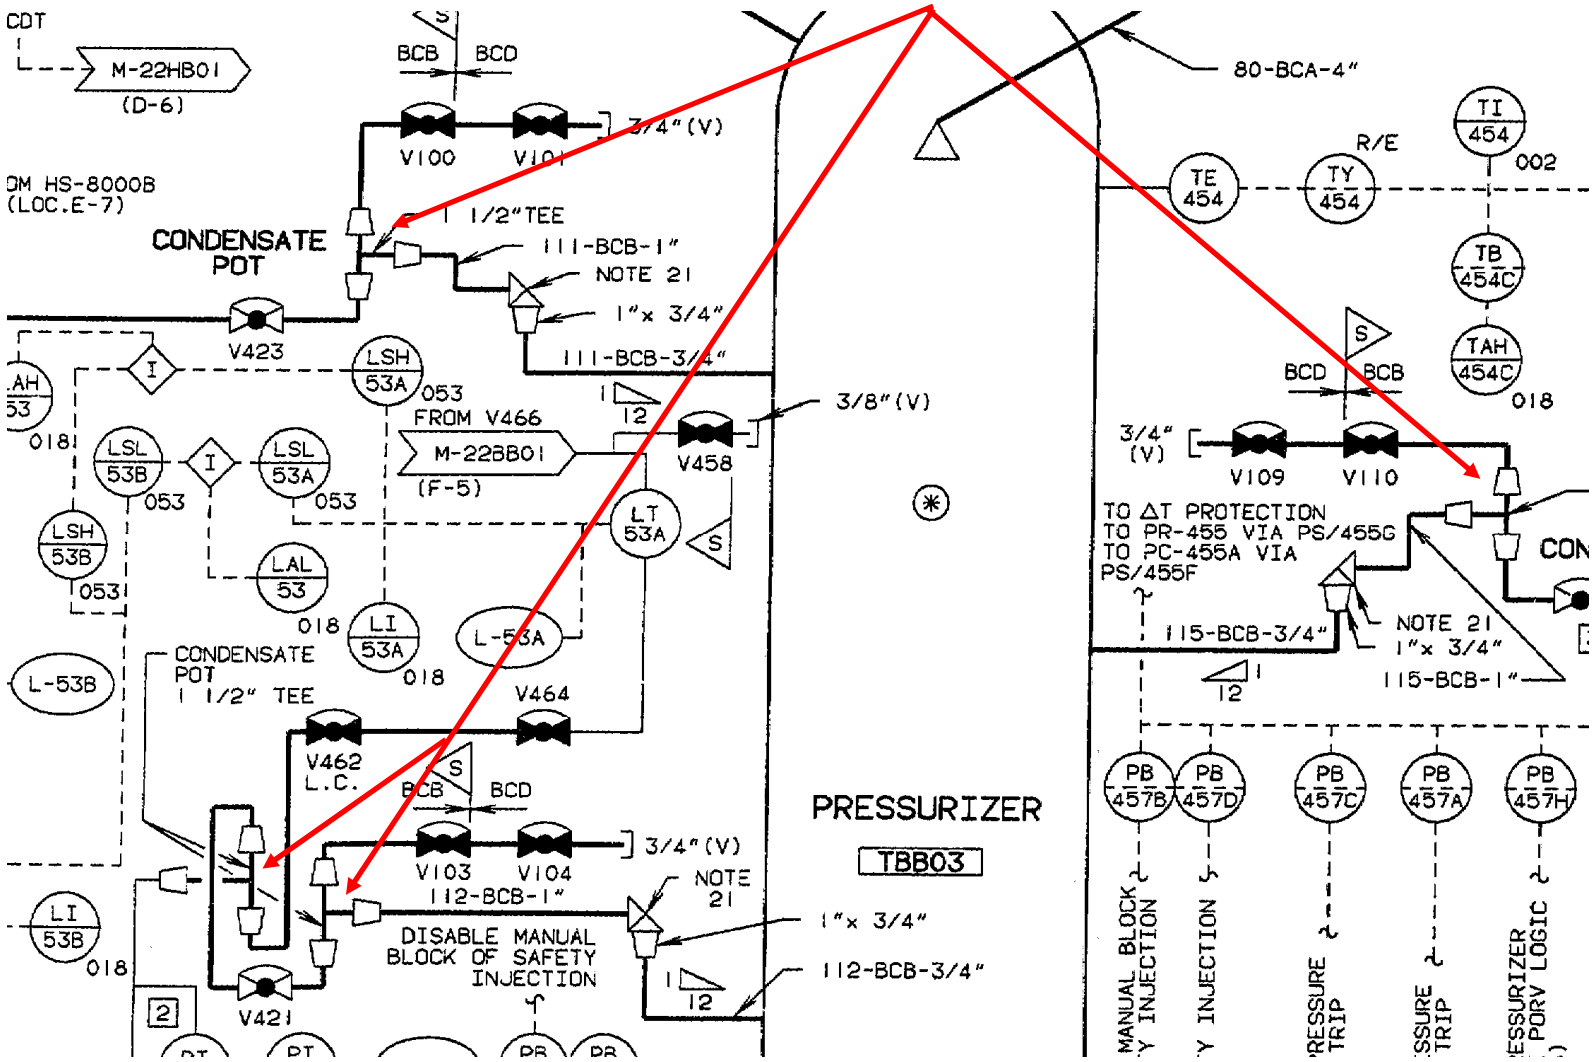
NRC Comment: [The licensee's initial] response is not adequate. It isn't clear what is the significance of considering the 1-1/2 x 3/4 reducer a fitting, as far as ASME Class 1 fatigue analysis is concerned. If the 1-1/2 end of the reducer is attached to ASME Class 1 piping, this end is not exempted from a Class 1 fatigue analysis, even though the 3/4 end is exempted. They have not provided adequate justification for not doing the Class 1 fatigue analysis of the 1-1/2 end.

Response: Callaway's original plant design included 1 1/2" tee fittings (Condensate Pots) connected to ASME Class 2 (BCB) lines. (See figure below.) No ASME Class 1 fatigue curves were required during the original design of the plant due to the ASME Class 2 classification of the adjacent lines.
